AFFIDAVIT
OF
GORMAN L. REYNOLDS

SUBJECT: RESPONSES TO NRC QUESTIONS ON CONTROL BLADE LIFE (B₄C
LOSS)

SUBJECT: RESPONSES TO NRC ADDITIONAL QUESTIONS ON CONTROL BLADE
LIFE (B₄C LOSS)

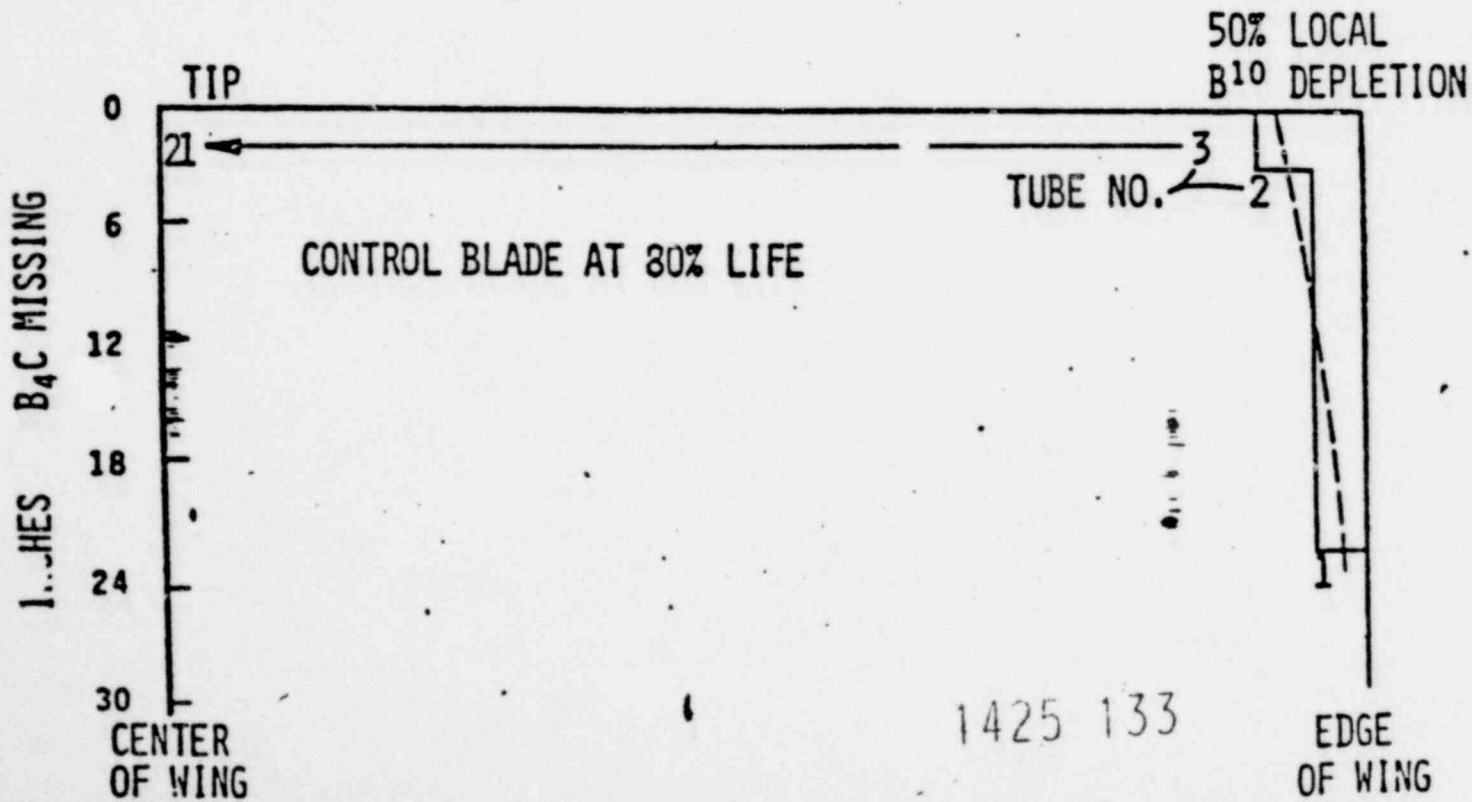
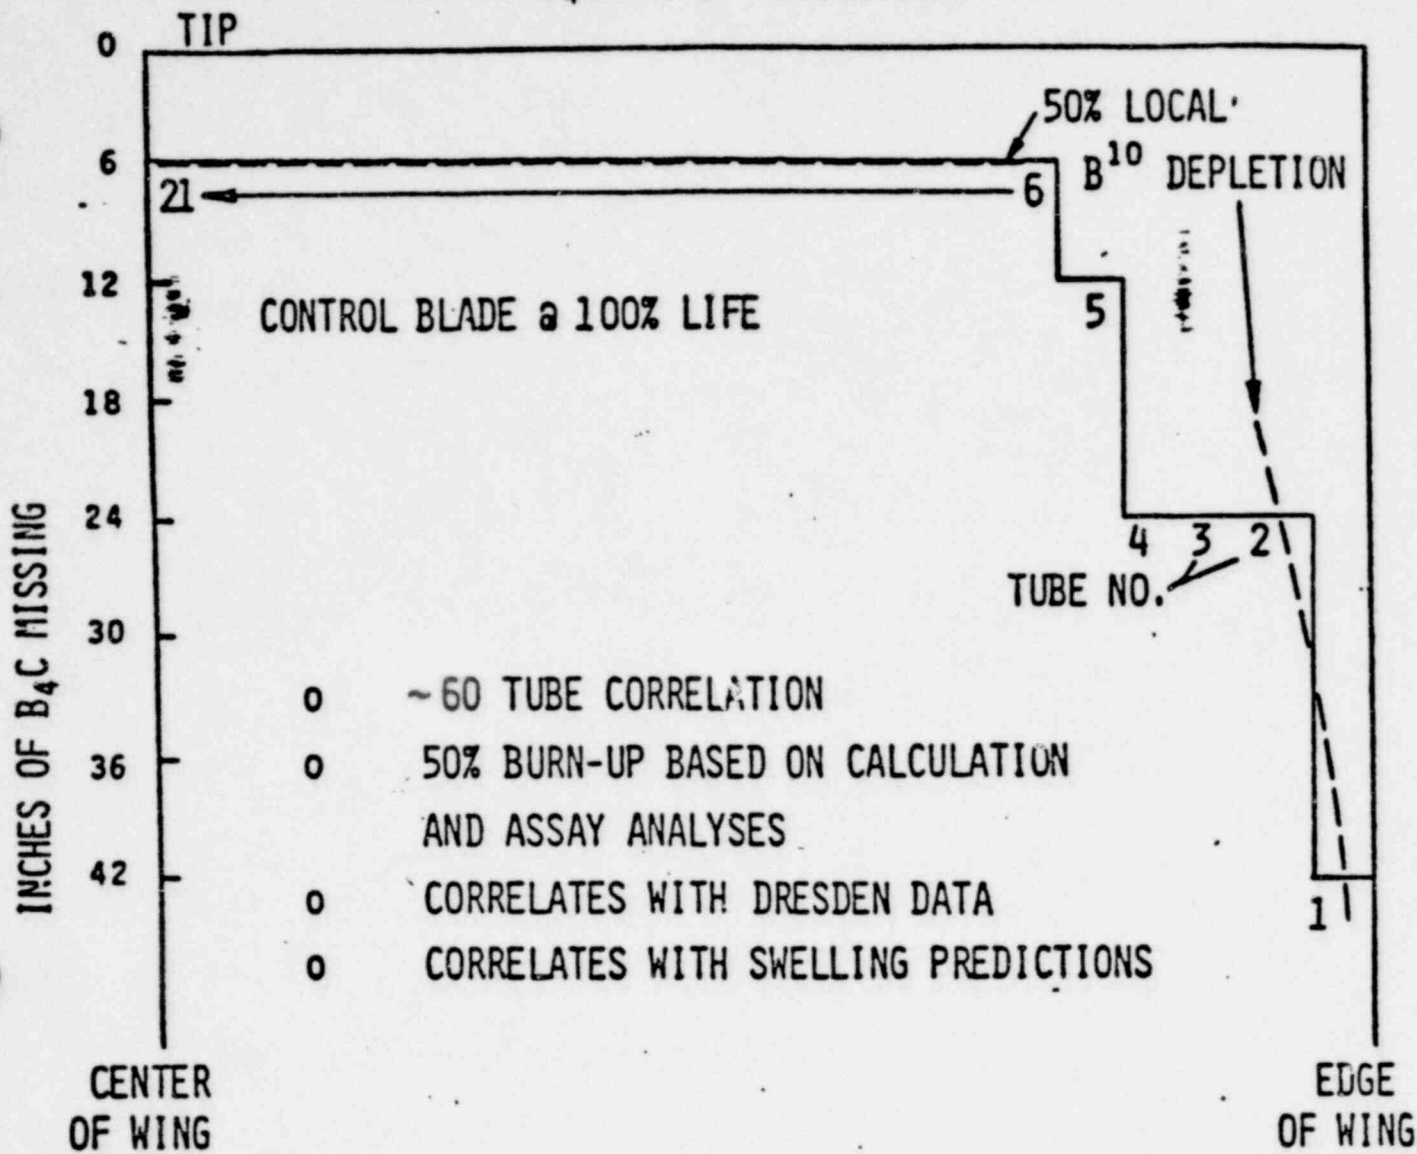
Question 3

The presence of B_4C as a function of B^{10} depletion shown in Figure 1 illustrates the type of B_4C loss which would be anticipated for a control blade at 80% of the previous design lifetime. This loss is based on neutron radiographs of tubes removed from a control blade at 80% of life. The amount of B_4C missing is small and has negligible impact on control rod reactivity worth and on core physics calculations impacted by control rod worth such as shutdown margin and scram reactivity. The B_4C is assumed to be gone at 50% local B^{10} depletion and no credit is taken for the fact that the missing B_4C had been depleted (i.e., the change in control rod worth is conservatively evaluated against fresh B_4C or a new control rod).

The local B^{10} depletion was determined experimentally by B^{10}/B^{11} assay analyses, and analytically by control blade burn up profiles which were calculated using Monte Carlo techniques for one control blade with no B_4C loss.¹ Assay analyses were performed in a hot cell using mass spectrometry. The assay analyses were performed on both sets of rods shown in Figure 1.

(Figure 1). By superimposing the analytically derived control blade burn up profiles on the B_4C loss data, it was determined that the 50% local burn up profile was the best fit to the B_4C loss profile. B^{10}/B^{11} assay analyses performed on one of the control blades with a crack but no B_4C loss at 100% of the previously defined control blade life confirmed that the peak burn up in the rod was 50%. For the absorber rods at 80% of previous life the assay samples were taken immediately below the point where the absence of B_4C was observed. The local burn up at this elevation was slightly higher than 50%.
